1. Inspection of the rudder pedals.
2. Change/supplement to the Flight and Maintenance Manuals in order to provide the owners with new inspection and assembly instructions.
3. Inspection and exchange of the airbrake bellcrank in the fuselage.
4. Inspection and if the case arises, reinforcement of the rear canopy hinge.

All serial no.s 21001 thru 21345 including;
this is factory-standard as of serial no. 21346.

Poppenhausen, den 16.10.1987

ALEXANDER SCHLEICHER
GmbH & Co.

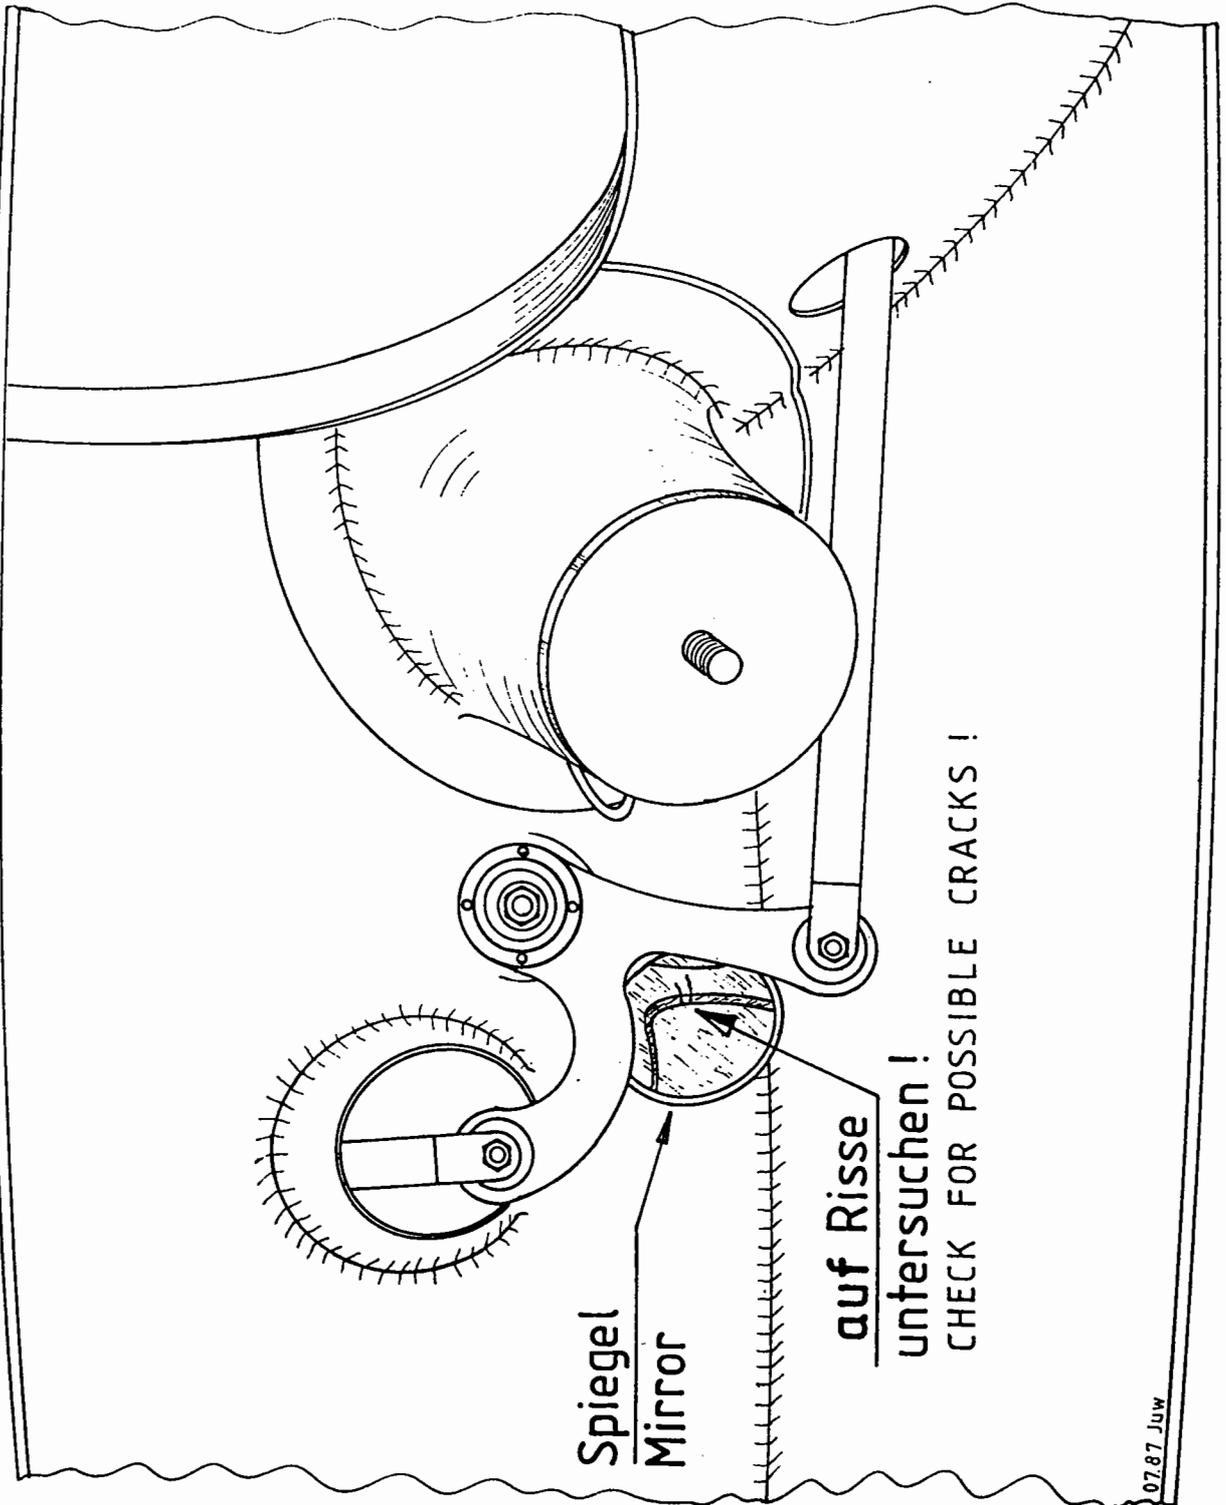
For the FAA-approved US-Edition of the manuals this applies to the following pages:-
Flight Manual: pp. 2, 3, 4, 30, 31, 42, 42a, 43.
Instructions For Continued
Airworthiness: pp. 2, 3, 43, 45, 45a, 45b, 60.
- 2.2 The accomplishment of the change/ supplement to the Manuals must be documented on the respective page "Amendments Record" (for the FAA-approved US-edition this applies to the page "Log Of Revisions").
- 2.3 The inspection and assembly instructions provided on the new manual pages must be duly regarded !
- 3.1 Prior to the next take-off it must be checked if the air-brake bellcrank in the fuselage shows cracks or deformations --> see Fig. 1.

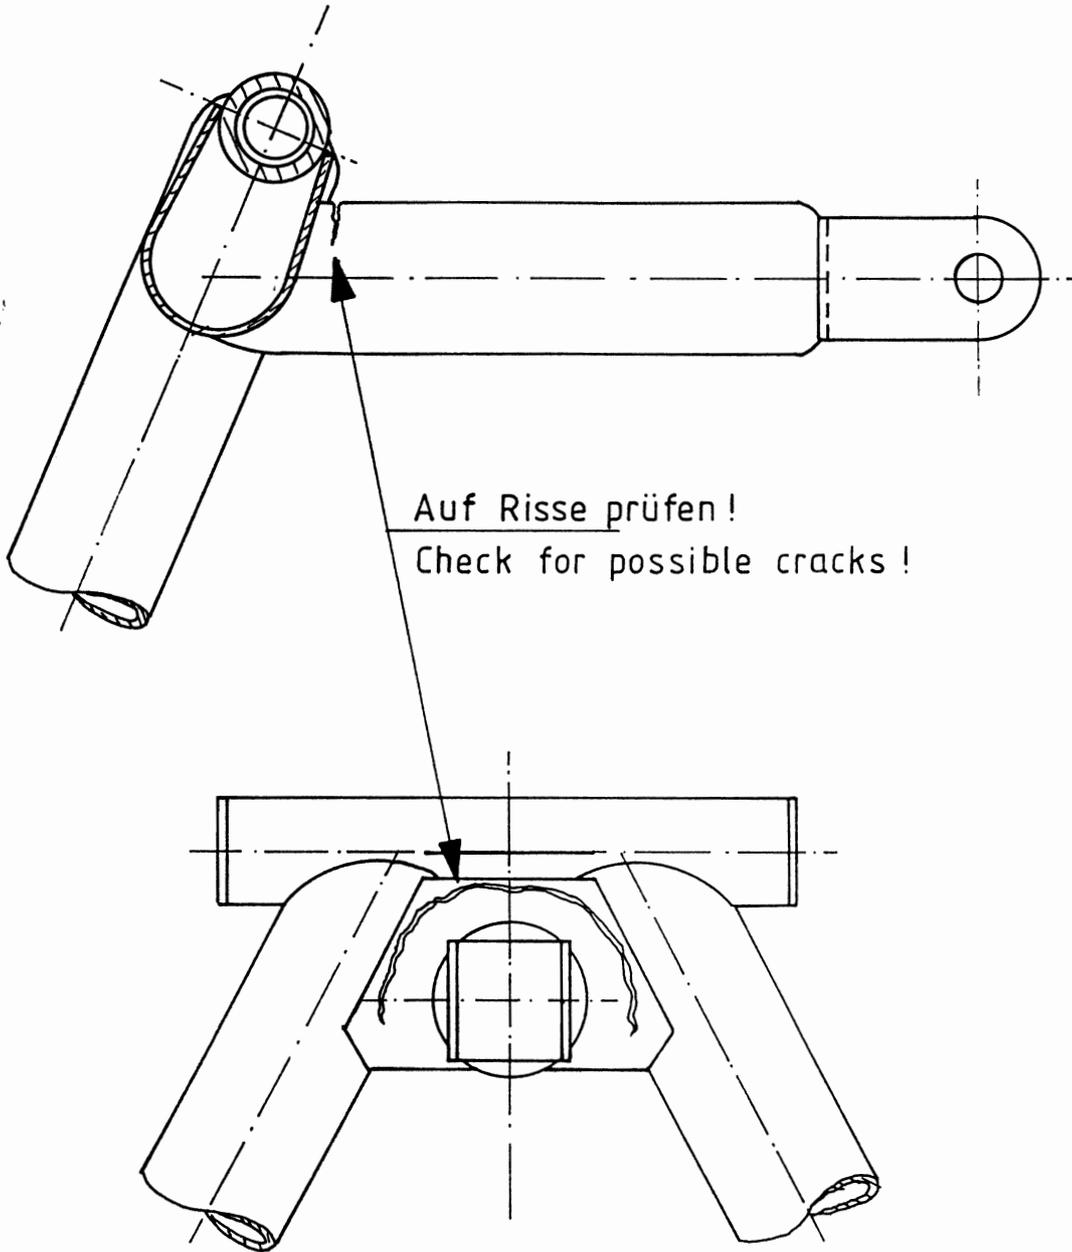
4.1 Prior to the next take-off it must be checked if the rear canopy hinge shows cracks --> see drawing 210.12.S5.

Auf Risse prüfen!
Check for possible cracks!

4.2 If cracks are found, prior to the next take-off the rear canopy must be disassembled and the canopy hinge must be reinforced as shown on drawing 210.12.S5.

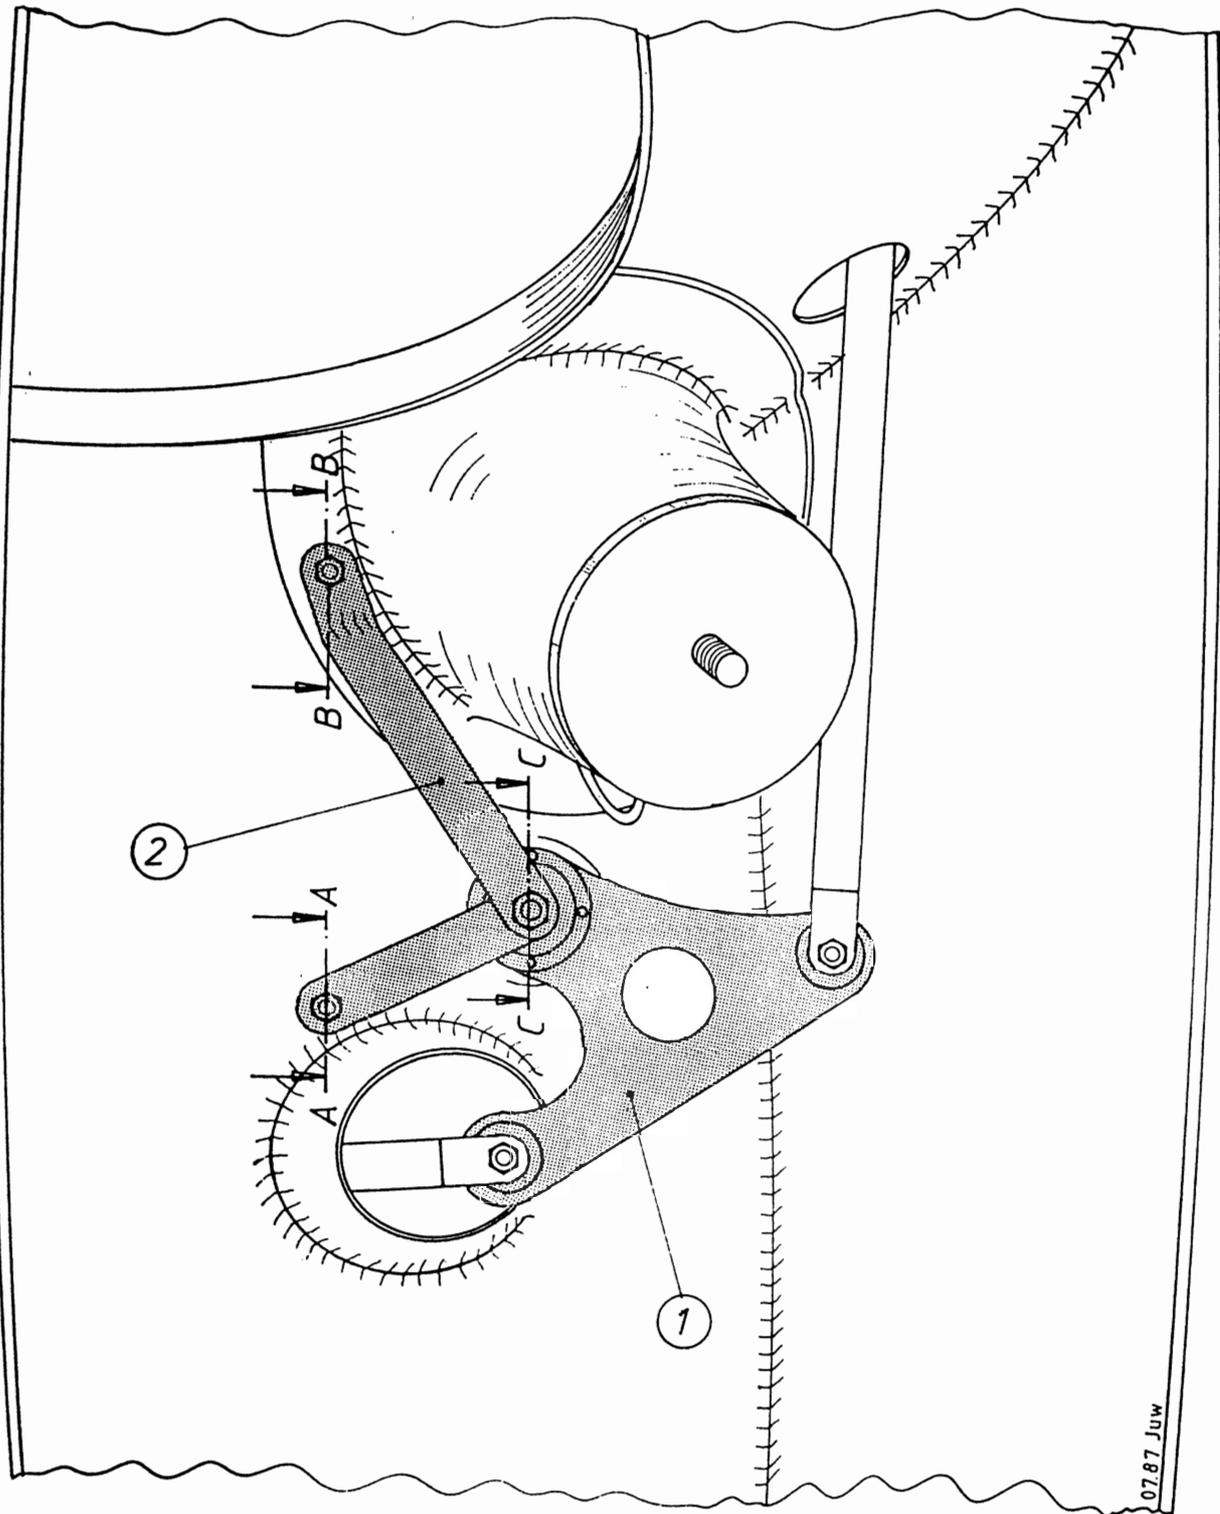
3.2 If cracks or deformations are found, the airbrake bellcrank must be removed prior to the next take-off and the new bellcrank with an additional support must be fitted --> see drawing 210.43.S5.

3.3 If no damages are found, flight operation can be continued for the present. Until the next annual glider re-inspection, however, at the latest by April 30, 1988, the new bellcrank in the fuselage (210.43.0005) must be fitted.
